**Re:** Responses to Comments from July 31<sup>st</sup> Hearing  
**Applicant:** TAG Central LLC  
**Project/Property:** Central Street Residences/444 East Central Street

Draft Conceptual Section  
 Central Street Residences

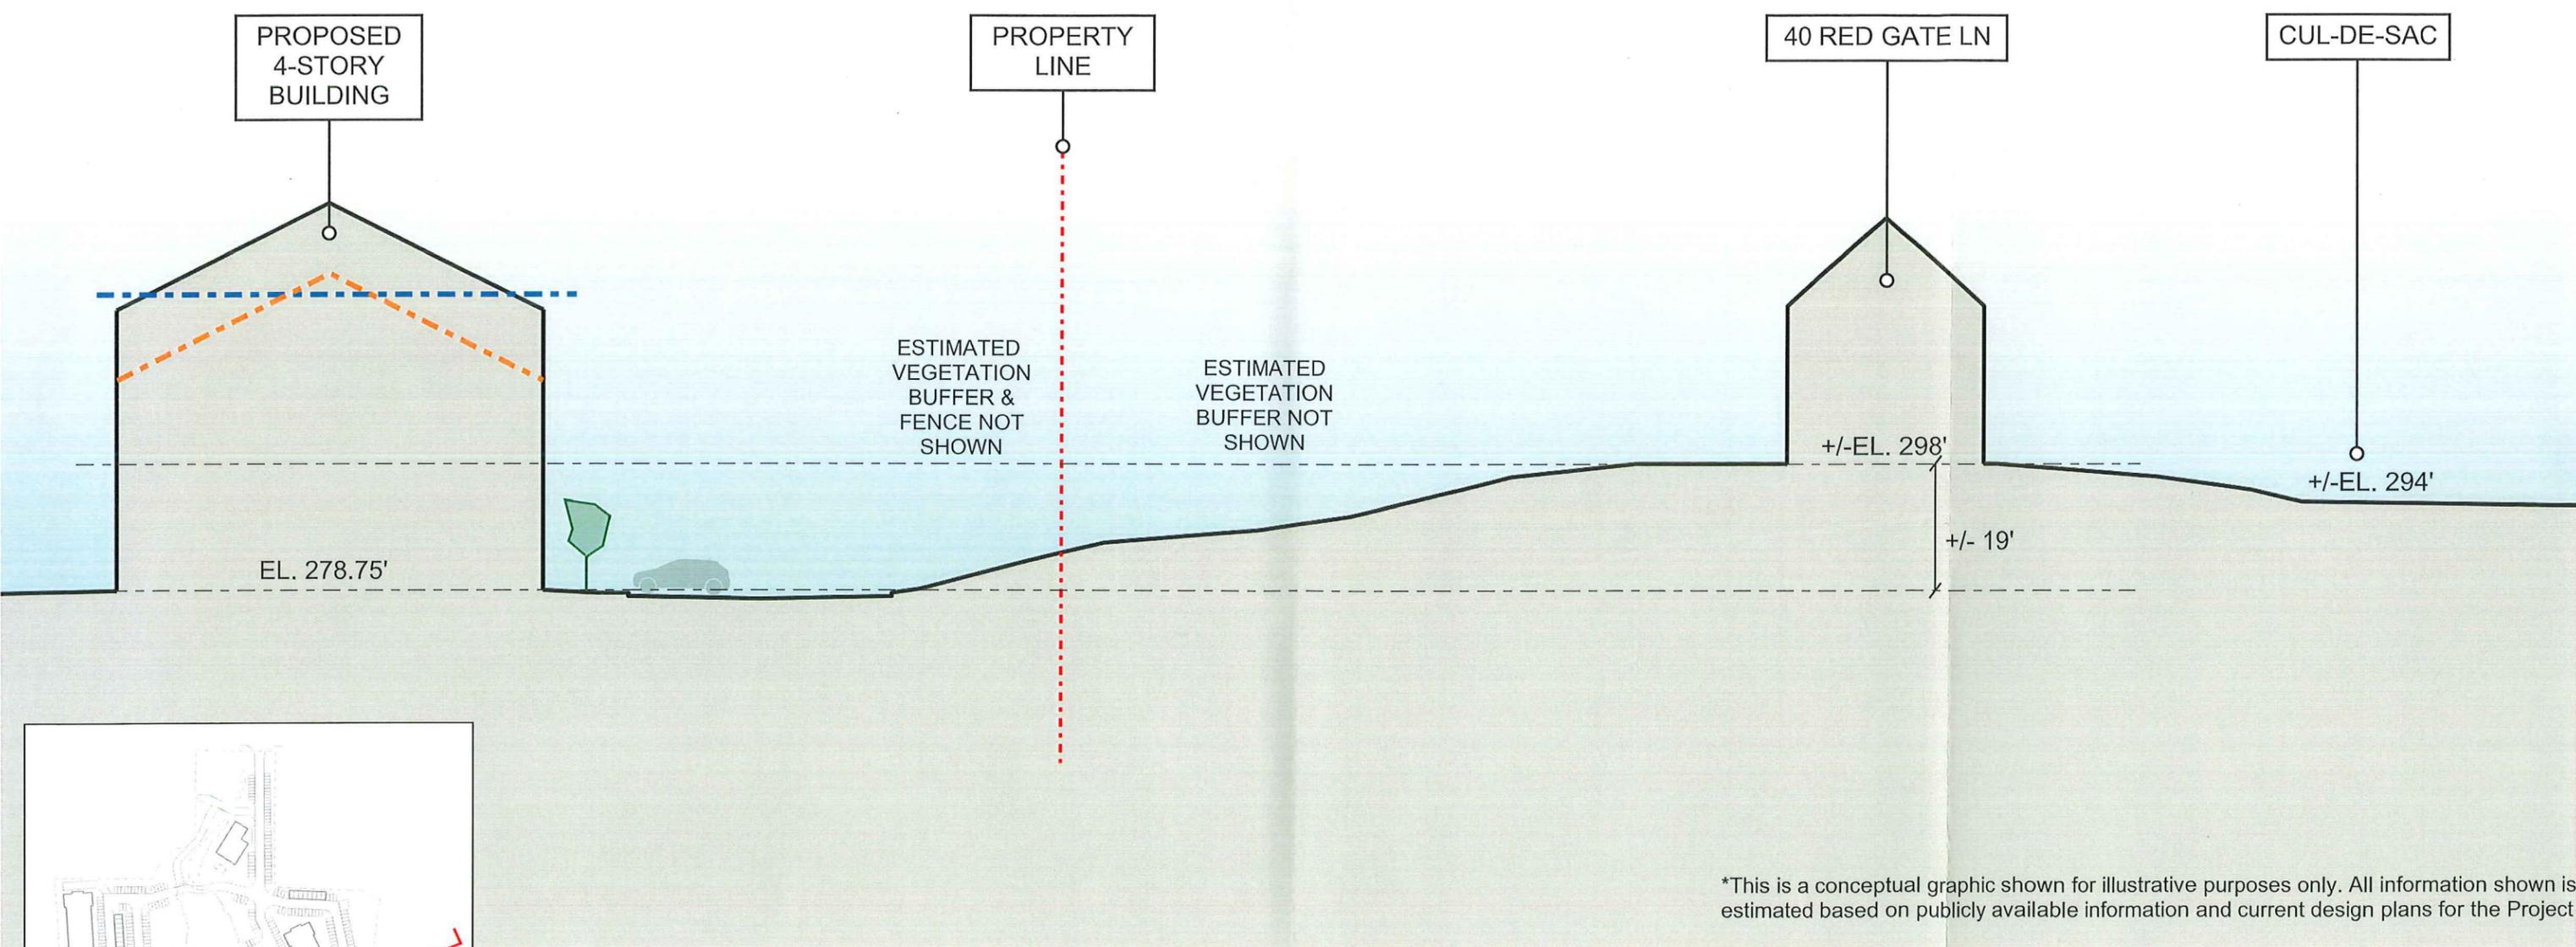
6. **Comment:** Please submit the building section diagram presented at the July 31<sup>st</sup> Hearing which shows the proposed project as it relates to the easterly abutting properties.

**Response:** As requested, please find the building section diagram presented at the July 31<sup>st</sup> Hearing attached.
